ATTACHMENTS FOR: AGENDA NO. 7/13 Planning and Environment Committee

Item		Page
2	305 BLAXLAND ROAD & 5-7 NORTH ROAD, RYDE. LOT 1 DP1069680 & LOT A&B DP 414322. Local Development Application for alterations and additions to San Antonio da Padova Nursing Home. LDA2012/247.	
	Attachment 2 Submissions from Kerry Gordon Planning Services on behalf of the Body Corporate of 1 Aeolus Avenue	2
	Attachment 3 Applicant's response to submissions received.....	18
4	20 WEST PARADE, EASTWOOD. LOT 2 DP 808844. Application pursuant to Section 96(1A) of the Environmental Planning and Assessment Act, 1979 to amend the trading hours for Landmark Hotel. LDA No. LDA2009/0700. Section 96 Application No. MOD2012/0203.	
	Attachment 2 Site Plan	30
	Attachment 3 Venue Management Plan	31
	Attachment 4 Report from Elton Consulting.....	52

**RE: EXTENSION OF AN EXISTING NURSING HOME TO INCREASE CAPACITY
FROM 50 TO 112 BEDS - DEVELOPMENT APPLICATION NO. LDA2012/0247**

RE: **AMENDED PLANS AND ADDITIONAL INFORMATION**
DEVELOPMENT APPLICATION LDA 2012/0247
S'ANTONIO DA PADOVA VILLAGE, 305 BLAXLAND ROAD RYDE

Current district views from upper level rear apartment in the front building on my client's site

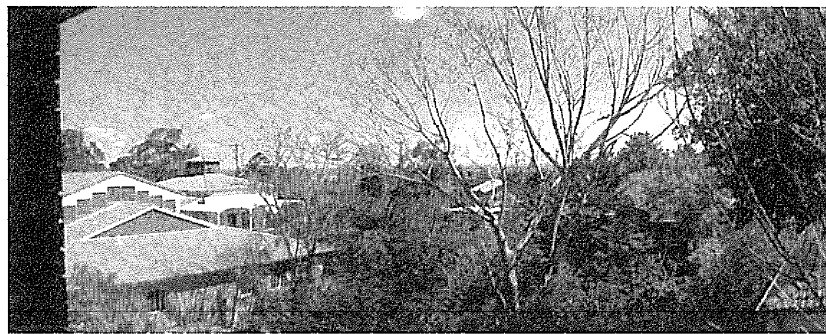
The following photograph shows the view from the balcony off the living room of an upper level apartment at the rear of the front building, with extensive district views. A development that complied with the height controls, including a maximum of two storeys adjacent to boundaries, would retain large portions of these views.

The current amended development would result in the total loss of the views. As the component of the development that results in the total loss of the view is a non-compliant element, I am of the opinion that the development fails the test set by the Planning Principles of the Land and Environment Court related to view sharing and as such the variation to the height control should not be supported in this instance. The attempt in the applicant's submission to dismiss this concern is indicative of the dismissive attitude the applicant has shown to the adjoining property owners throughout this process.

Similar views are enjoyed from other rooms within this apartment and from other apartments, all of which would be lost as a result of the proposal. Such a view loss could not have been expected by the owners, and is not justifiable, as the proposal is two storeys higher than the control allows at this point. Given this impact the SEPP 1 objection to the height variation is not well-founded.

Outlook from middle level bedroom of apartment within Building A

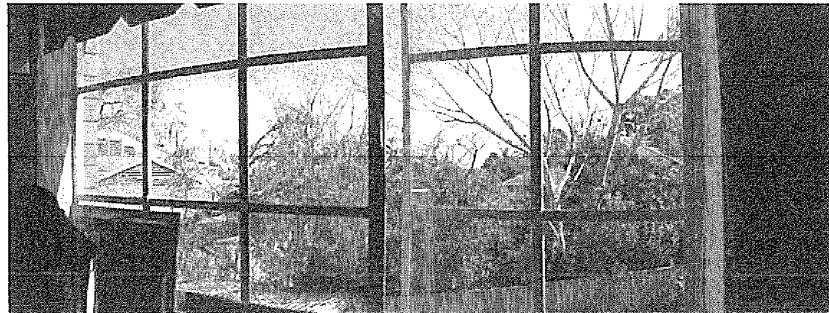
Further, the excessive height of the development will result in an unacceptable visual bulk impact upon the living areas, balconies and bedrooms of the apartments in Building A (see following photograph).

Current district views from upper level rear apartment in Building A

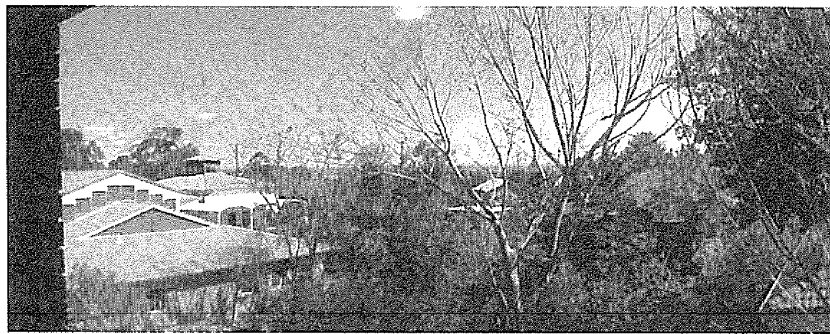
The following photograph shows the view from the balcony off the living room of an upper level apartment at the rear of Building A, with extensive district views. A development that complied with the height controls, including a maximum of two storeys adjacent to boundaries, would retain large portions of these views. The current proposed development would result in the total loss of the views. As the component of the development that results in the total loss of the view is a non-compliant element, I am of the opinion that the development fails the test set by the Planning Principles of the Land and Environment Court related to view sharing and as such the variation to the height control should not be supported in this instance.

Similar views are enjoyed from other rooms within this apartment and from other apartments, all of which would be lost as a result of the proposal.
